Subject: Waterford 3 SES
Docket No. 50-382
License No. NPF-38
Change No. 2 to Cycle 11 Core Operating Limits Report

Change No. 2 to Cycle 11
Core Operating Limits Report

CHANGE NO. 2

COLR Figure 5

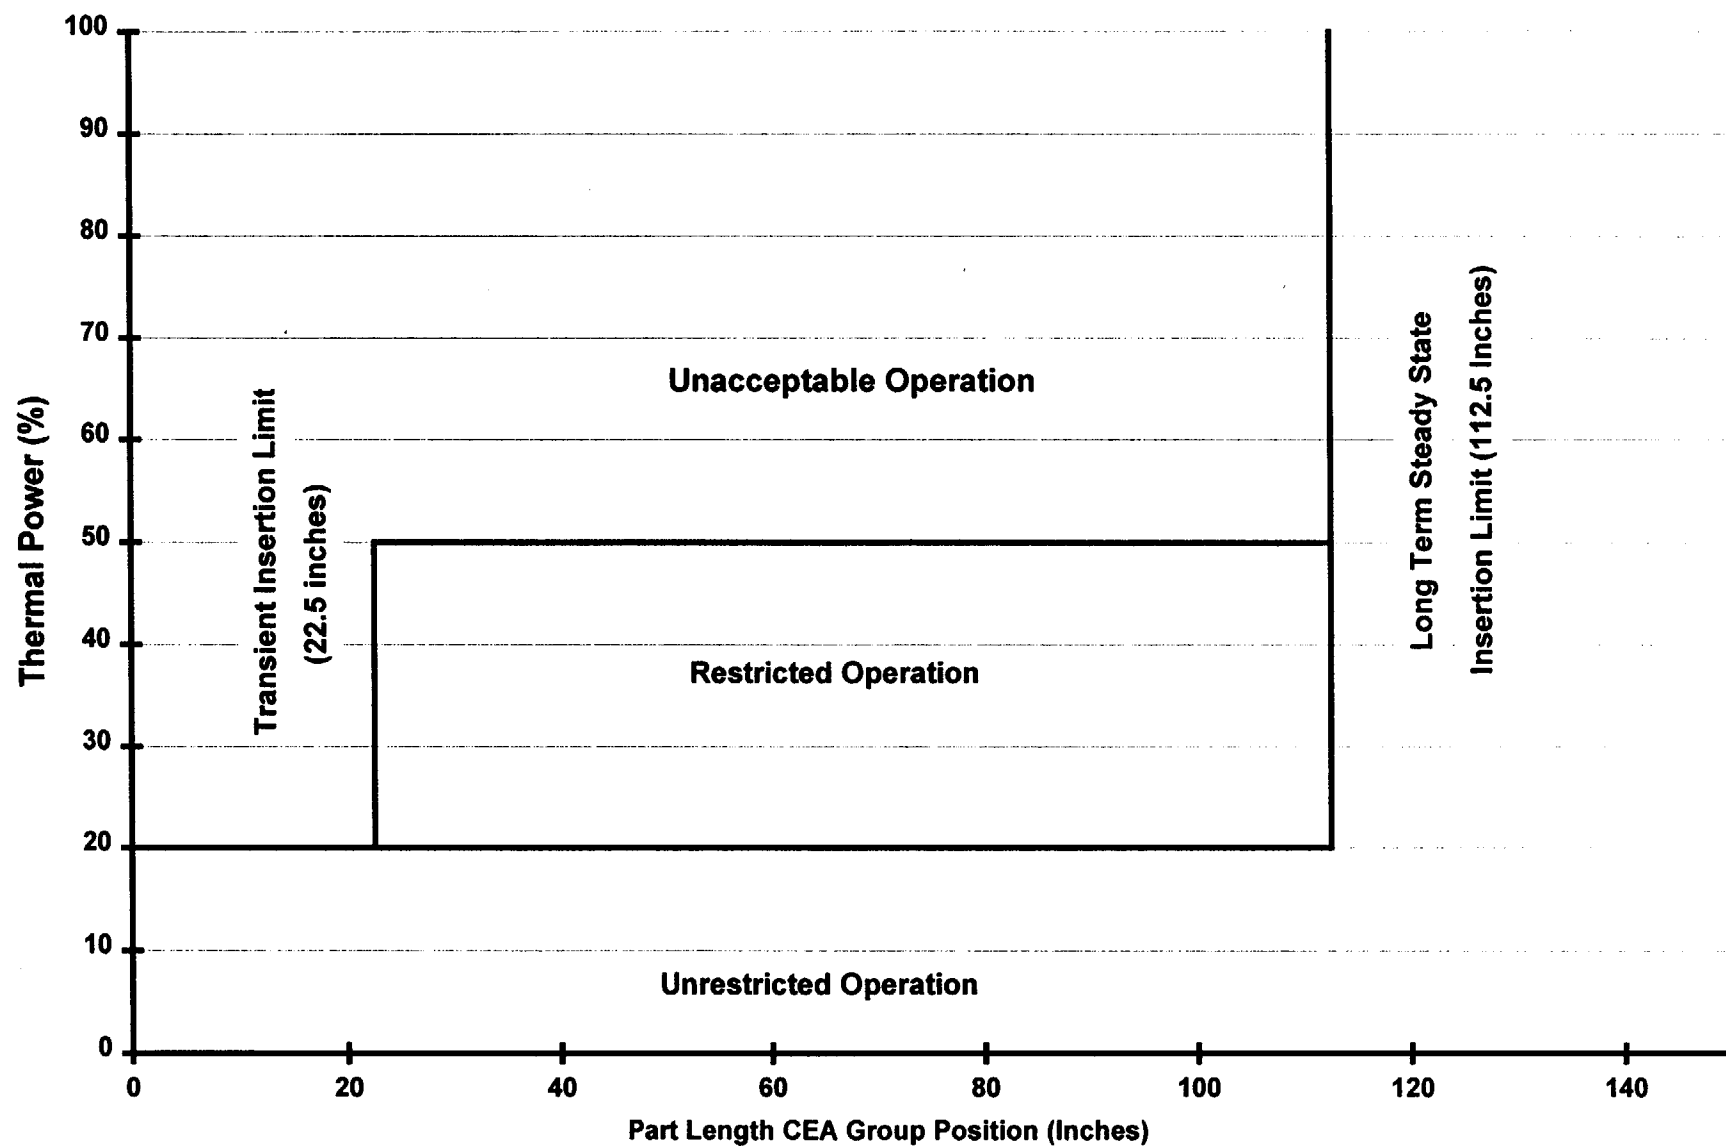
In accordance with the 50.59 Evaluation #00-068 for ER-W3-00-0853-00-00, Replacement of Pressurizer Proportional Heaters, Section 3.1.3.7 COLR Figure 5 was revised to restrict the part-length rods to 25 percent inserted (112.5 inches withdrawn) for all power levels until the Moderator Temperature Coefficient (MTC) at 50% power and below is confirmed to be more negative than the limits presented in the table below. This restriction will apply to power levels below 20% because the thermal margin requirements at 20% are used to define and bound those at lower powers. Technical Specifications (TS) 3.1.3.7, Part Length CEA Insertion Limits, is only applicable in Mode 1 above 20% thermal power. However, during Cycle 11 while the restriction is required, administrative controls will be employed to ensure the new COLR Figure is applied at all power levels.

50.59 Evaluation #00-068 for ER-W3-00-0853-00-00, Replacement of Pressurizer Proportional Heaters, revised Section 3.1.3.7 COLR Figure 5 to restrict the part-length rods to 25 percent inserted (112.5 inches withdrawn) for all power levels until the Moderator Temperature Coefficient (MTC) at 50% power and below was confirmed to be more negative than the limits presented in the table specified in Change No. 1 above. In accordance with Entergy Operations inter-office memo CEO-2000/00254, the most limiting of the power level conditions was the 0% power case where the MTC becomes more negative than $-0.2 \text{ E-4 } \Delta\rho/^\circ\text{F}$ at a burnup of 172.31 Effective Full Power Days (EFPD). Administrative controls were also implemented to ensure the new COLR Figure was applied at all power levels.

In accordance with Operations Station Log, dated May 21, 2001, and the Reactor Engineer's system log, the current burnup in Cycle 11 is greater than 172.31 EFPD; therefore, it is acceptable to remove the current restrictions on PLCEA position imposed through COLR Change No. 1 and return to using the original restrictions specified in Figure 5 of Cycle 11 COLR Revision 0 that was evaluated in Safety Evaluation #00-061. In addition, the administrative controls implemented through Deviation C to OP-100-014, Technical Specifications and Technical Requirements Compliance, can be removed.

Power level, % of rated			
	0	20	50	70
MTC limits above which PLR restriction and BERR1 penalty apply, ($\times 10^{-4} \Delta\rho/^\circ\text{F}$)	-0.2	-0.2	-0.5	-0.7
